# GREATER LONDON AUTHORITY

Our reference: MGLA070622-2567

*In relation to the above planning application please find attached an addendum to my previous written representations (last one sent on the 4th of February). This responds to the applicants latest published documents and concerns Carbon Emissions, BREEAM compliance, Whole Life Cycle Carbon and Urban Greening.*

Fig. 4.10.1 Window on Electric Avenue

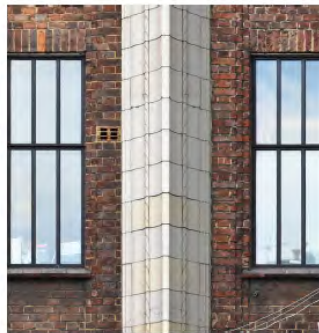
This type of design for structure and fabric lends itself to **thermal bridging weaknesses**, but there is no explanation of how these weaknesses will be overcome. It is suggested therefore that the assumed standard allowance of **10% for thermal bridging is unrealistic**, particularly since these details occur repetitively throughout the building.

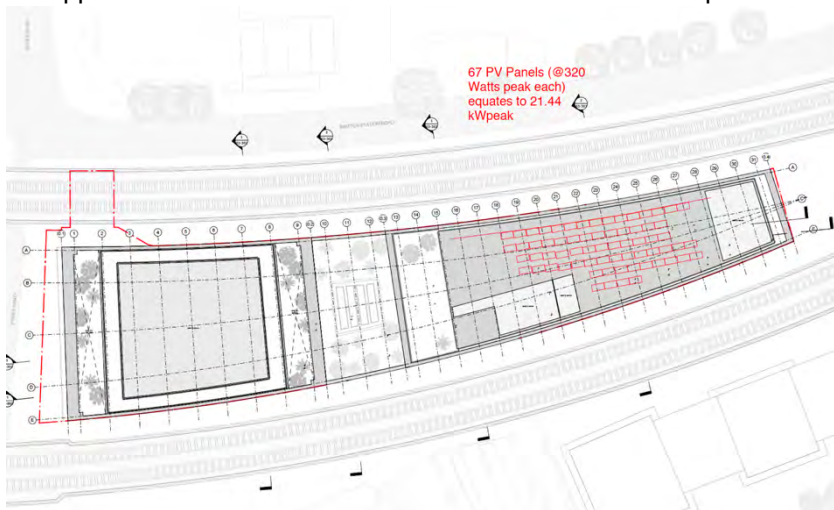
It therefore follows that this green roofing would cover the entire east block roof apart from the plant rooms that are shown on the architect's drawings as being 'open to above'. However the PV roof plan submitted by the applicant in Jan 2022 shows that there would be 67 PV panels on the east block roof- see below.

This means that  $67 \times 1.68 = 112.5$  sqm of the east block roof would be taken up with PV panels, so rather than the full 533 sqm of roof space being available for green roofing, only 420.44 sqm would be available unless the PV panels were either elevated or spaced further apart. Without such strategies (and these are not indicated in the applicant's report) the total UFG contribution would reduce to 716.4 and the UGF would reduce to  $714.6/2573 = 0.27$  i.e. below the 0.3 required to meet London Plan policy G5.

9am

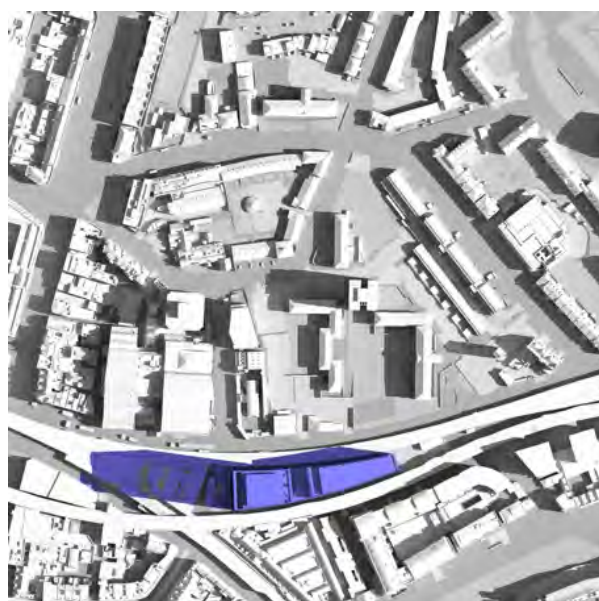
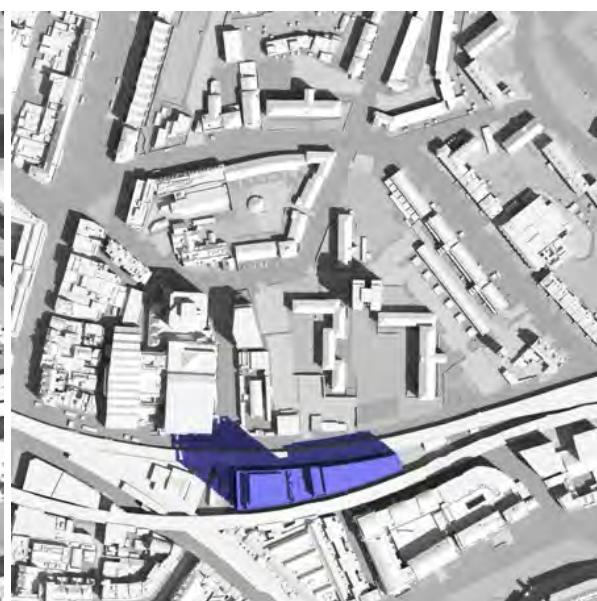
Extracts below from the applicant's sunlight and daylight report reveals, the development would plunge the Popes road pedestrian area and Brixton Station Road into shadow during the summer months. These images show the impact at 9am and 11am on 21st June.

This canyon effect is also contrary to Lambeth Plan policy Q7 (Urban Design--new development):
